102-04516-AKK/SAB/JAP  
December 20, 2000

**Subject: Palo Verde Nuclear Generating Station (PVNGS)  
Unit 2, Docket No. STN 50-529  
Core Operating Limits Report (COLR), Unit 2, Revision 3**

**Core Operating Limits Report  
PVNGS Unit 2, Revision 3**

FIGURE 3.1.7-1

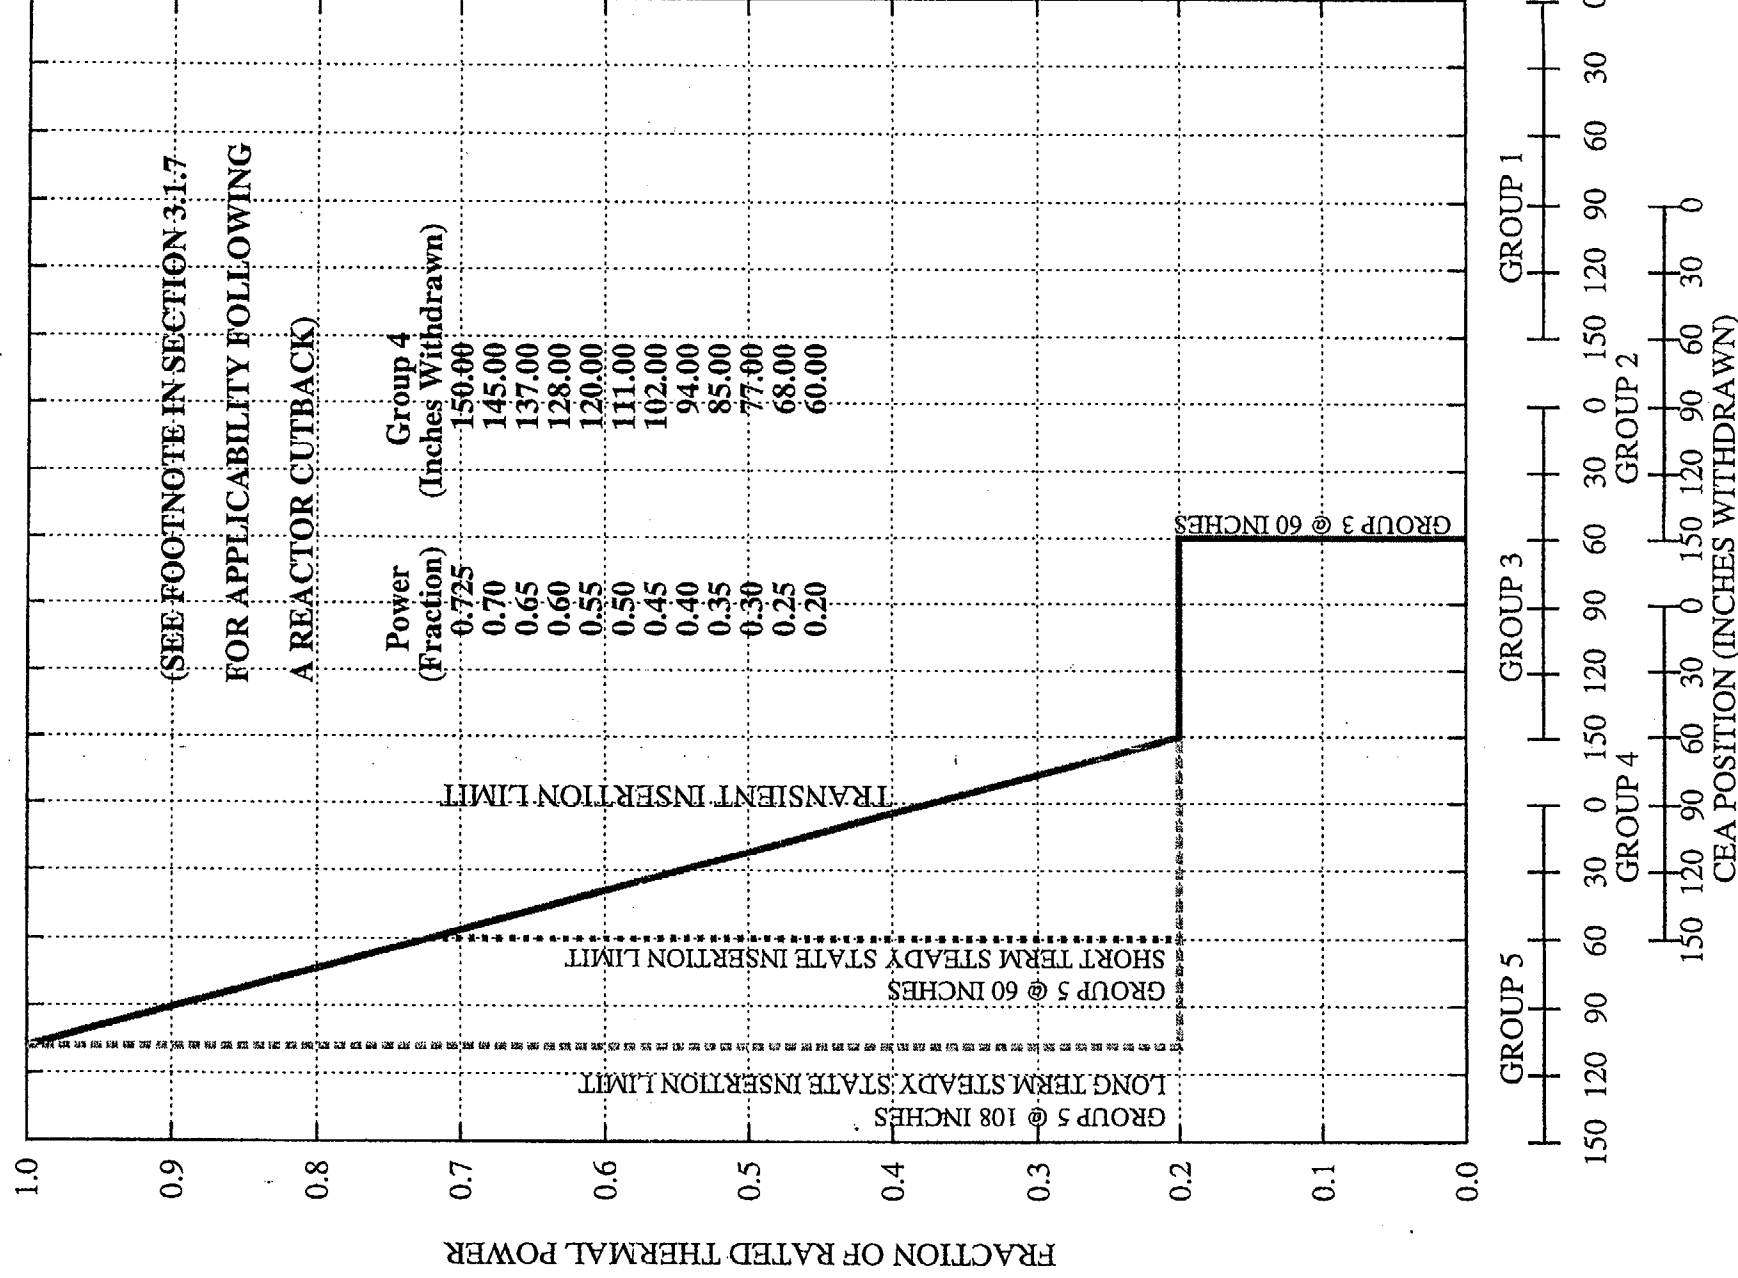
Pursuant to PVNGS Technical Specifications, Section 5.6.5.d, enclosed is Revision 3 to the COLR for Unit 2, which was made effective on December 14, 2000. This revision revises Figures 3.1.7-1 and 3.1.7-2 with additional tabular information as an aide to users, Figure 3.2.3-1 for Azimuthal Power Tilt limit above 20% power, and miscellaneous editorial changes. This revision replaces the previous Unit 2 COLR, Revision 2.

One or more CEACs OPERABLE: With COLSS IN SERVICE, regulating CEA groups shall be limited to the withdrawal sequence and to the insertion limits<sup>1</sup> shown in Figure 3.1.7-1; with COLSS OUT OF SERVICE, regulation CEA groups shall be limited to the withdrawal sequence and to the insertion limits<sup>1</sup> shown in Figure 3.1.7-2.
